Access Compliance Report

Public Rights-of-Way

Intersection ID: 49273	Main Street: REMINISCE_LN	Cross Street: REUNION_ST	Location:	W
ADA ID: 72E37AE0567A	Ramp Type: Perp	Initial Pass/Fail: Fail	Overall Compliance: No	Severity Score: 25

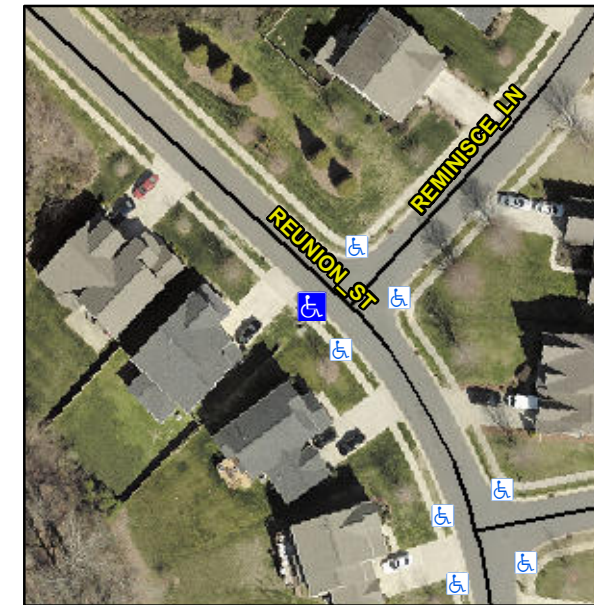
Not Found, R304.5.3

Compliance	Description	Data	Compliance	Description	Data
N/A	Ramp Length (in)	49.0	Yes	Ramp Slope (%)	6.1
Yes	Ramp Width (in)	48.0	No	Ramp XSlope (%)	7.6
N/A	Flare Type LT	N/A	N/A	Flare Type RT	N/A
N/A	Flare Slope LT (%)	N/A	N/A	Flare Slope RT (%)	N/A
N/A	Flare Traversable LT?	N/A	N/A	Flare Traversable RT?	N/A
N/A	Landing Length (in)	N/A	N/A	DWS Provided?	N/A
N/A	Landing Width (in)	N/A	N/A	DWS Contrast?	N/A
N/A	Landing Slope (%)	N/A	N/A	DWS Length (in)	N/A
N/A	Landing X Slope (%)	N/A	N/A	DWS Full Width?	N/A
N/A	Landing Curb? (Y/N)	N/A	N/A	DWS Offset (in)	N/A
N/A	Shared Landing?	N/A			
N/A	Gutter Ponding?	N/A	N/A	Gutter Slope (%)	N/A
N/A	Gutter Lip Ht (in)	N/A	N/A	Gutter X Slope (%)	N/A
N/A	Painted X Walk1?	No	N/A	Painted X Walk2?	N/A
	X Walk 1 Direction	To NE		X Walk 2 Direction	N/A
N/A	X Walk 1 Width (in)	N/A	N/A	X Walk 2 Width (in)	N/A
	X Walk 1 Slope (%)	2.8		X Walk 2 Slope (%)	N/A
	X Walk 1 X Slope (%)	7.6		X Walk 2 X Slope (%)	N/A

Remove & Replace Entire Ramp.
